**TAG - THORP ARCH TRADING ESTATE ACTION GROUP  
OBJECTION TO PLANNING APPLICATION 16/05226/OT**

## **Volume 10. Objection to Planning Application 16/05226 for 874 dwellings etc.**

### **Highway Objection.**

**Appendix A – Cross Section of Highway and Pavement on Bridge Road**

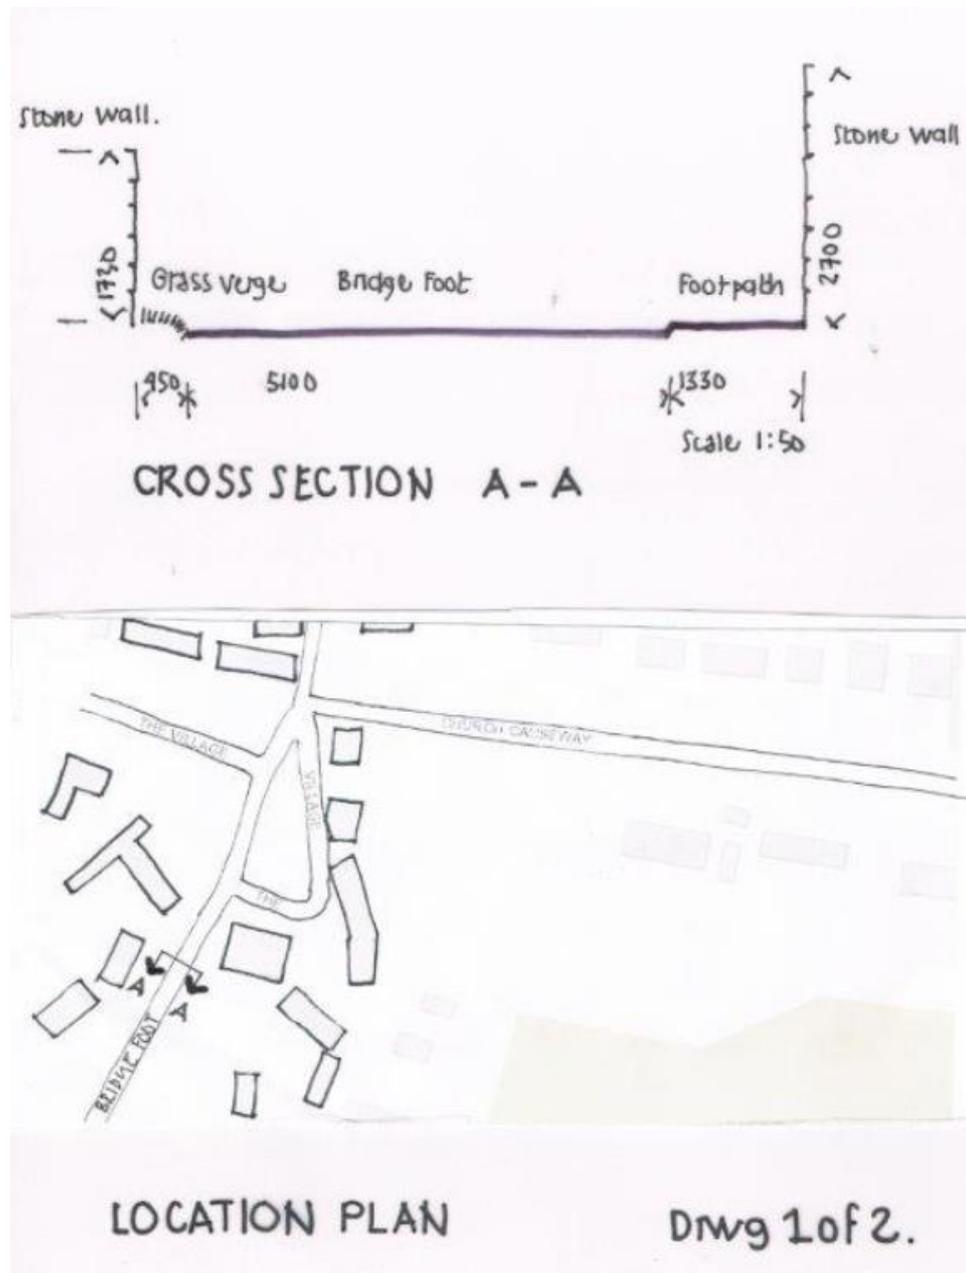
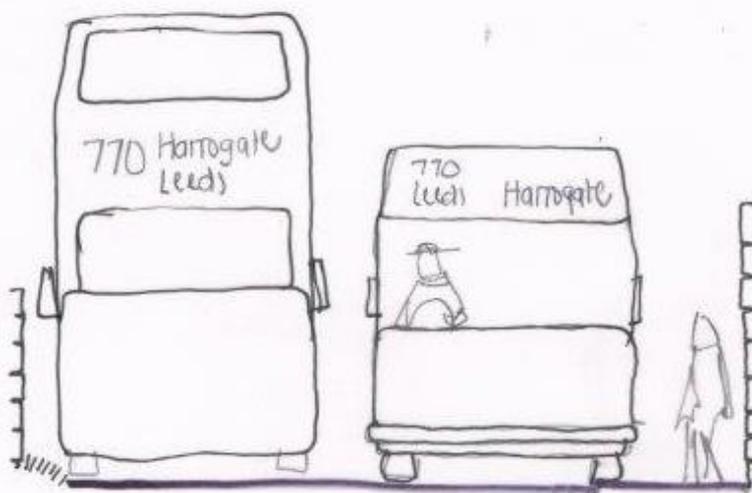
The carriageway narrows to 5.1m, with a 1.3m footway on one side only. The bend, narrow road and high walls gives poor visibility, particularly for north bound vehicles that are often forced to mount the pavement to avoid a collision. For pedestrians the narrow pavement and high walls mean there is nowhere to 'escape' when a north bound vehicle is forced onto the footway. The dimensions and layout of the road are shown in Appendix A.
